PlanGrid Task Report - May 31, 2024

04884_New Bern Ave FSU (NC)

4411 New Bern Avenue, Raleigh, North Carolina

IMG_4345

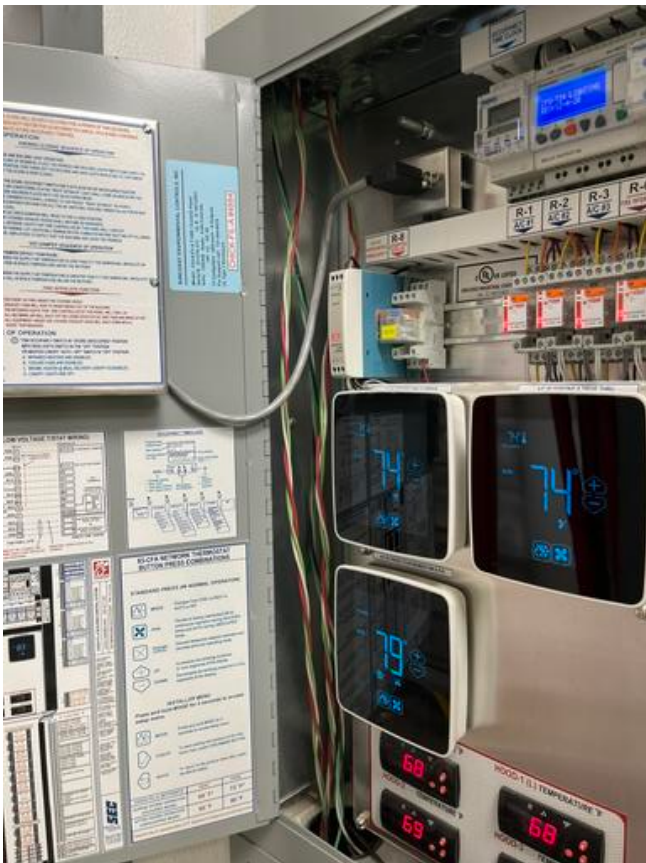
#37 [CNTL 999] [NEW] (MISC) T-500

T-500 panel needs high voltage wiring cover installed.
